GROUP  
CHA

MODEL  
2016MY  
Optima (JF)

NUMBER  
095

**SUBJECT:** FRONT STRUT FLANGE NUT REPLACEMENT

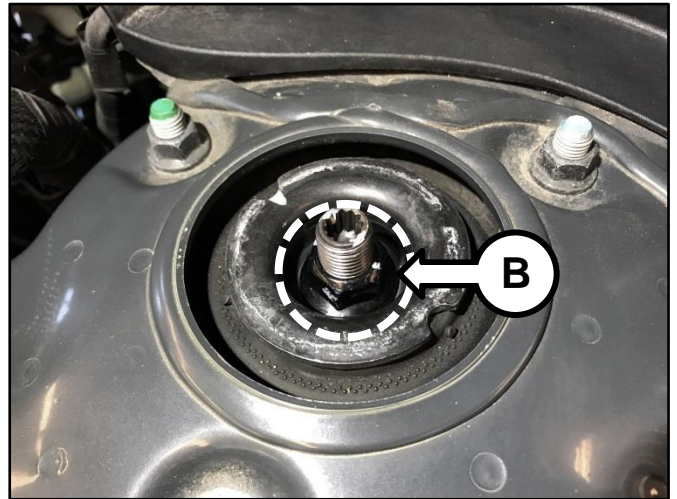
1. Remove both front strut mount caps (A).

2. Remove and replace both front strut flange nuts (B) and torque the new nuts to specifications.

**Tightening torque:**  
79.6 – 86.8 lb.ft (107.9 – 117.7 N.m,  
11 – 12 kgf.m)

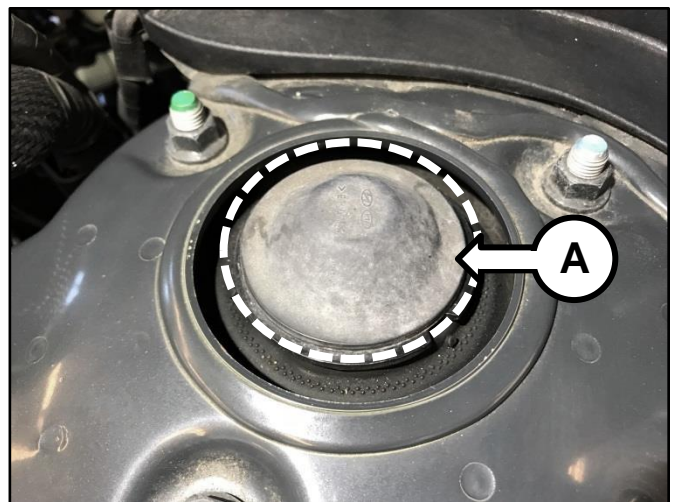
3. Reinstall the front strut mount caps (A).
